PART C: 1963, 1964 AND 1965 CORVETTE CROSS MEMBER ISOLATION MOUNTS - TSE DATED 11/29/65

**SUBJECT: REAR SUSPENSION CROSSMEMBER
ISOLATION MOUNTS LOOSENING -
1963, 1964 AND 1965 CORVETTES**

BULLETIN NO. TSB #1174

FIGURE 1

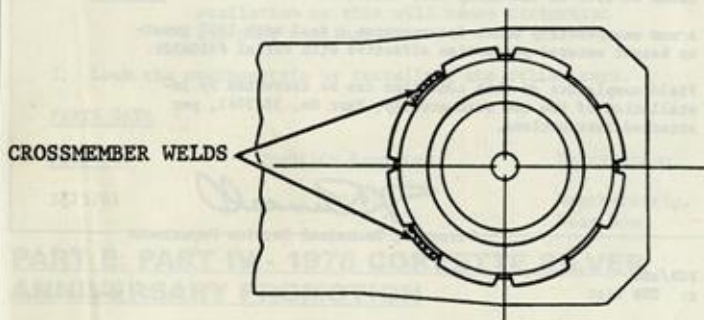
1. Remove the crossmember, then remove the old mount and clean the mount cavity in the crossmember.
2. Coat the new mount and cavity with chassis grease and with tabs positioned to straddle the crossmember welds, Figure 1, press the new mount into the crossmember applying force to the outer sleeve.
3. Bend all retaining tabs over tightly against the crossmember.
4. Reinstall the rear crossmember. The crossmember-to-frame bolts should be torqued to 55-65 ft. lbs. The torque specification of 20-30 ft. lbs. in the 1964 and 1965 Corvette Shop Manual Supplement and the 1966 Chassis Service Manual is incorrect and should be crossed out.
